Access Compliance Report

Public Rights-of-Way

(Curb Ramps)

Intersection ID: 9738	Main Street: CAMBRIDGE COMMONS DR	Cross Street: HORNWOOD CT	Location:	S
ADA ID: 0A3EA71CB443	Ramp Type: PerpDiag	Initial Pass/Fail: Fail	Overall Compliance: No	Severity Score: 35
Codes/Mitigation Info/Possible Solution		Field Measurements/Component Compliance

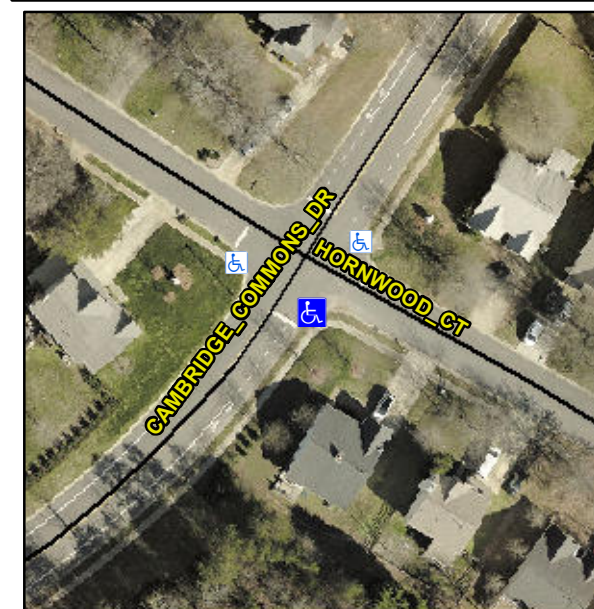
Not Found, R304.5.1

Compliance	Description	Data	Compliance	Description	Data
N/A	Ramp Length (in)	96.0	Yes	Ramp Slope (%)	5.5
No	Ramp Width (in)	29.0	Yes	Ramp XSlope (%)	1.8
N/A	Flare Type LT	N/A	N/A	Flare Type RT	N/A
N/A	Flare Slope LT (%)	N/A	N/A	Flare Slope RT (%)	N/A
N/A	Flare Traversable LT?	N/A	N/A	Flare Traversable RT?	N/A
N/A	Landing Length (in)	N/A	N/A	DWS Provided?	N/A
N/A	Landing Width (in)	N/A	N/A	DWS Contrast?	N/A
N/A	Landing Slope (%)	N/A	N/A	DWS Length (in)	N/A
N/A	Landing X Slope (%)	N/A	N/A	DWS Full Width?	N/A
N/A	Landing Curb? (Y/N)	N/A	N/A	DWS Offset (in)	N/A
N/A	Shared Landing?	N/A			
N/A	Gutter Ponding?	N/A	N/A	Gutter Slope (%)	N/A
N/A	Gutter Lip Ht (in)	0.5	N/A	Gutter X Slope (%)	N/A
N/A	Painted X Walk1?	No	N/A	Painted X Walk2?	No
	X Walk 1 Direction	To NE		X Walk 2 Direction	To NW
N/A	X Walk 1 Width (in)	N/A	N/A	X Walk 2 Width (in)	N/A
	X Walk 1 Slope (%)	0.4		X Walk 2 Slope (%)	2.4
	X Walk 1 X Slope (%)	1.7		X Walk 2 X Slope (%)	4.4

Remove & Replace Curb Ramp With Two New Directional Ramps or Equivalent.
